BAR Meeting
November 1, 2017

ISSUE: Partial Demolition. Alterations and Waiver of Rooftop Screening Requirement

LOCATION: 808 Duke Street

Proposed Side Elevation
Scale 1/8"=1'0"

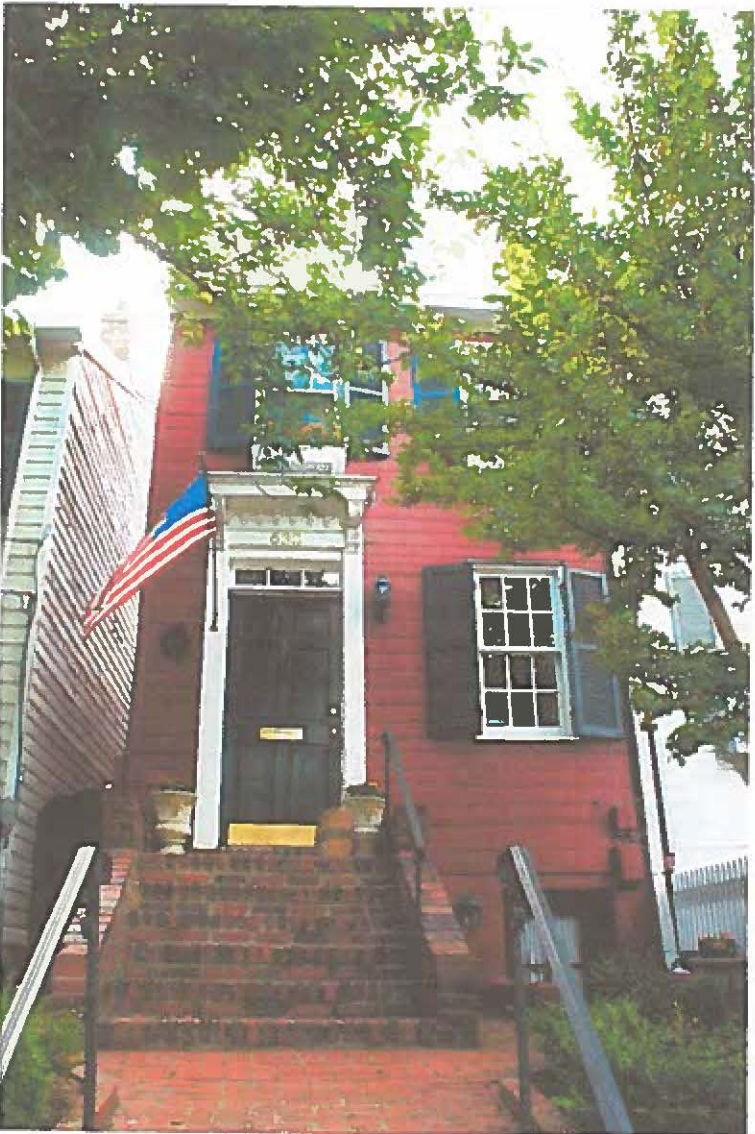
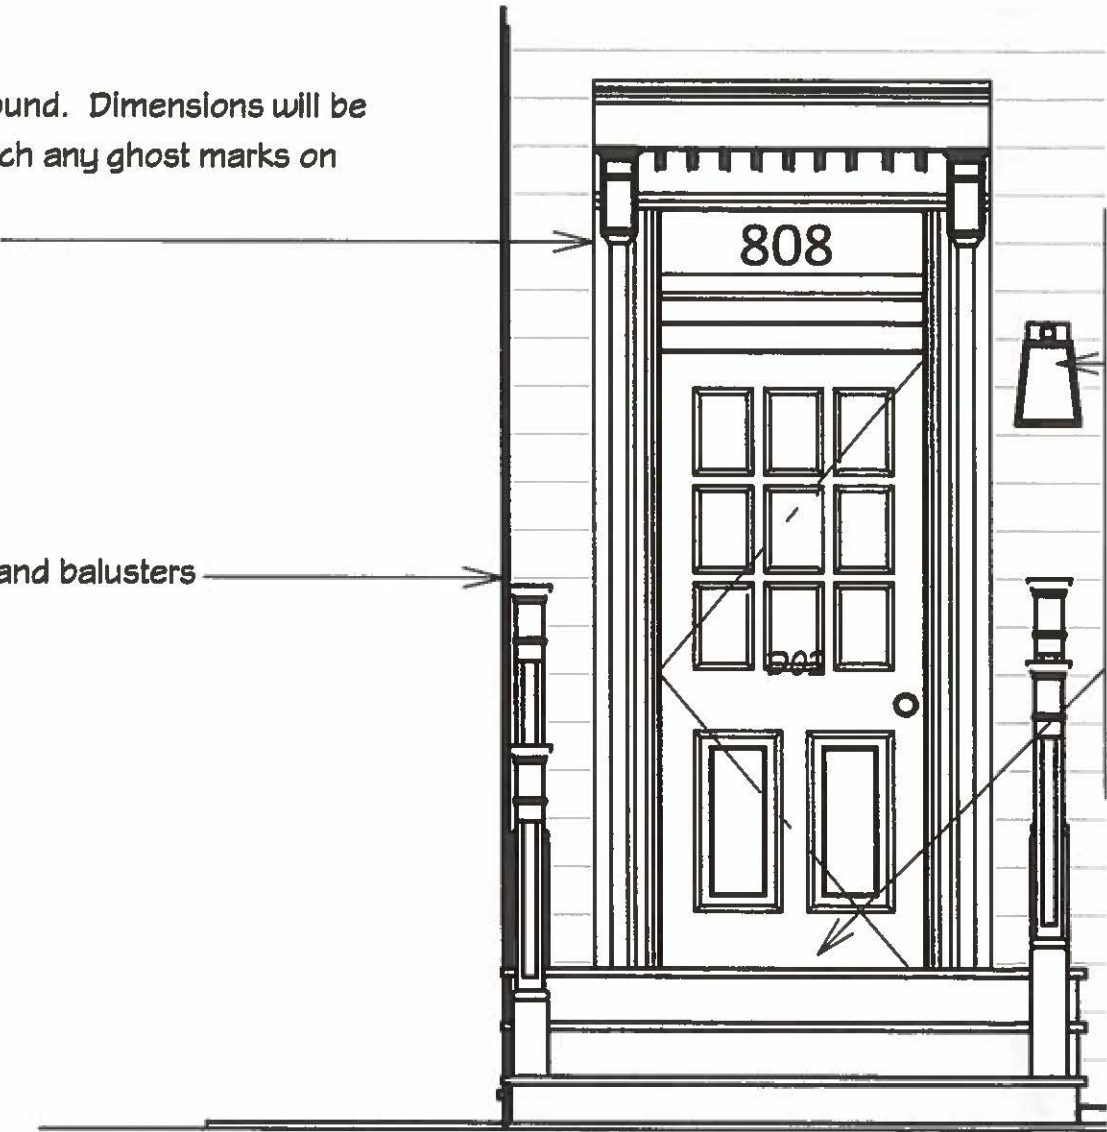
Staff has visited the site on a number of occasions and identified eight historic 2/2 windows with cylinder glass (Figure 3), which staff recommends be repaired and retained, rather than replaced, based on the BAR's window policy. Staff supports replacement of existing windows that are not historic, but recommends that the vertical muntin be the 2" width available from this manufacturer, rather than the 1' 1/8" proposed by the applicant, to be more compatible with the wide muntins on the historic windows. The replacement window materials submitted by the applicant otherwise comply with the BAR's window policy.

Figure 3: West and South elevations with the 8 historic windows identified by staff in the field

3. Retain the existing glass transom and decorative trim below and integrate it in the design of the new door surround;
4. Repair and retain the identified historic two-over-two windows;

5. New two-over-two wood replacement windows must have 2" muntins rather than the 1 1/8" muntin proposed by the applicant; and
6. The statements in archaeology conditions below shall appear in the General Notes of all construction documents that involve demolition or ground disturbance (including Basement/Foundation Plans, Demolition, Erosion and Sediment Control, Grading, Landscaping, Utilities, and Sheeting and Shoring) so that on-site contractors are aware of the requirements.
